STATE OF CALIFORNIA
PUBLIC UTILITIES COMMISSION
505 VAN NESS AVENUE
SAN FRANCISCO, CA 94102-3298

SUBJECT: Commission Resolution SU-40 changes to General Orders 95 and
128

Resolution SU-40

RULES FOR OVERHEAD LINE CONSTRUCTION, GENERAL ORDER NO. 95 STATE
OF CALIFORNIA PUBLIC UTILITIES COMMISSION

F. CLIMBING SPACE IN RACK CONSTRUCTION (see App. G, Fig. 32 Figure 54-23)

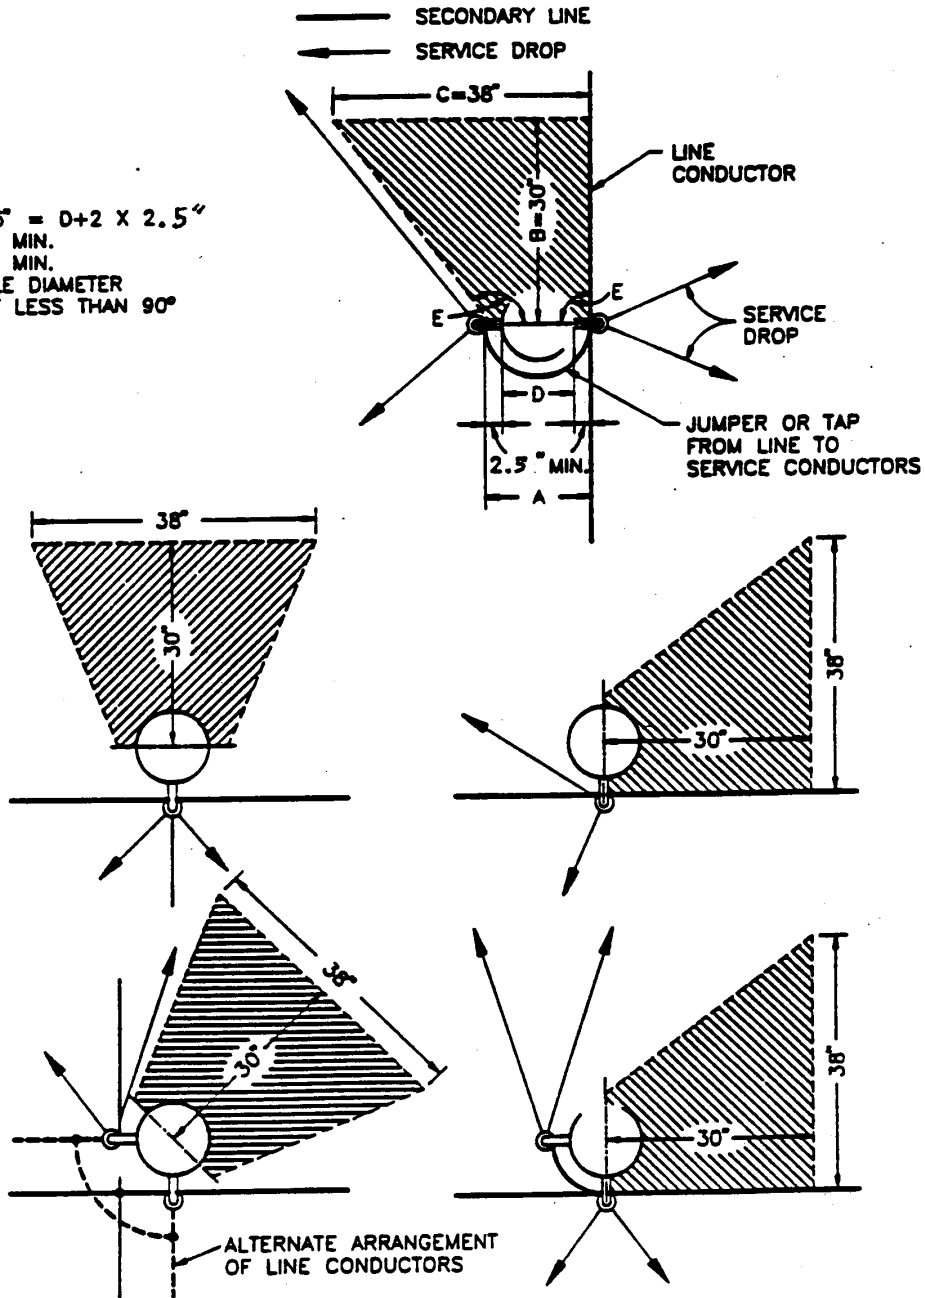
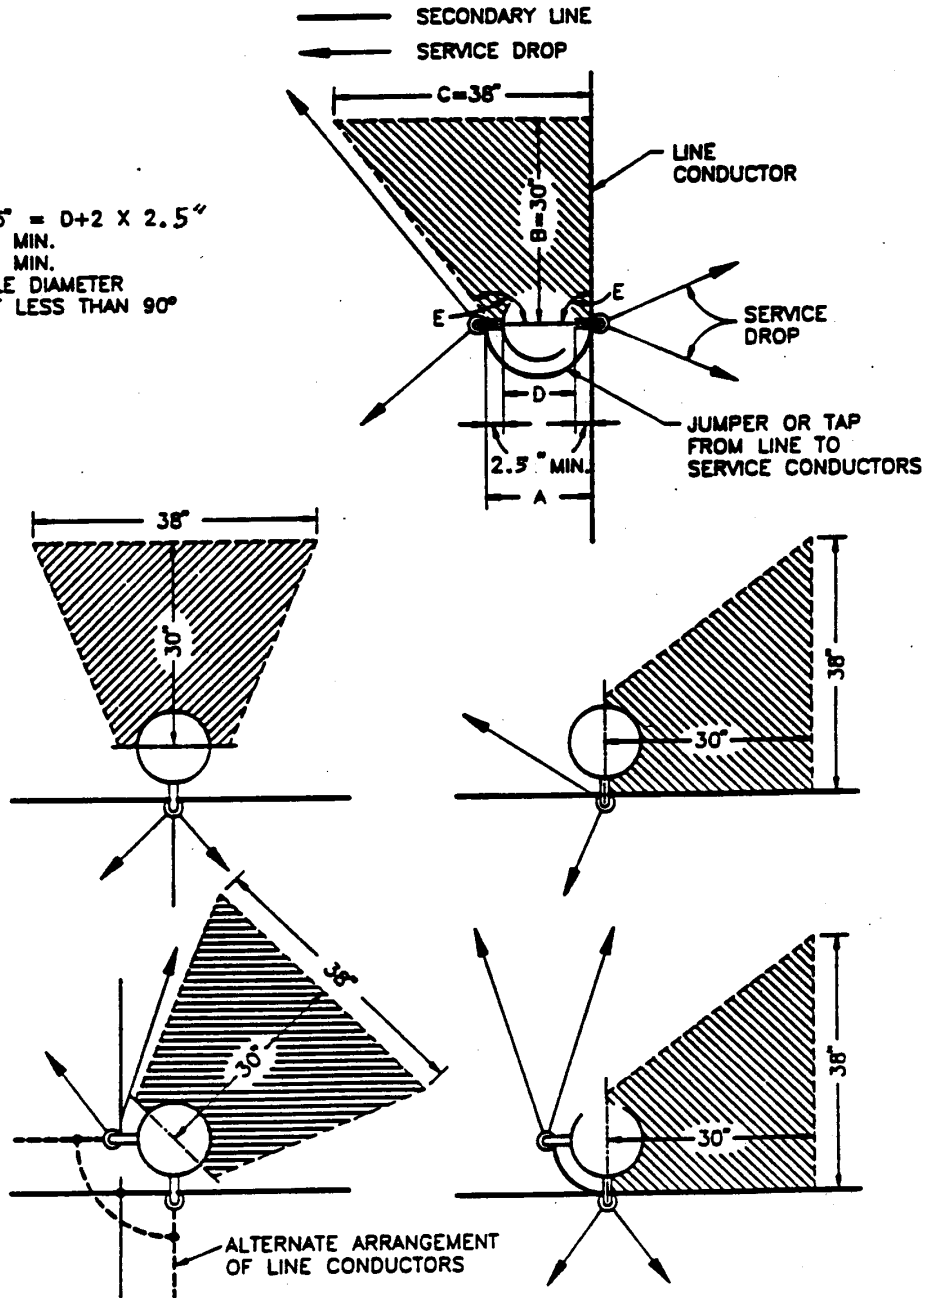
The width of the climbing space measured horizontally through the centerline ~~the~~ of pole shall be not ~~be~~ less than 5 inches plus the diameter of the pole and the extremities of such width shall be equidistant from the centerline of pole. The depth of the climbing space shall be not ~~be~~ less than 30 inches measured perpendicularly to this climbing space boundary through the centerline of pole. The width of the climbing space, perpendicular to and at the extremity of this 30- inch depth dimension, shall be not ~~be~~ less than 38 inches and neither of the other two side boundaries shall make an angle of less than 90 degrees with the boundary through the centerline of pole ~~(see App. G, Fig. 32)~~. (See Figure 54-23).

The width of the climbing space measured horizontally through the centerline of the pole shall not be less than 5 inches plus the diameter of the pole and the extremities of such width shall be equidistant from the centerline of pole. The depth of the climbing space shall not be less than 30 inches measured perpendicularly to this climbing space boundary through the centerline of pole. The width of the climbing space, perpendicular to and at the extremity of this 30-inch depth dimension, shall not be less than 38 inches and neither of the other two side boundaries shall make an angle of less than 90 degrees with the boundary through the centerline of pole (See Figure 54-23).
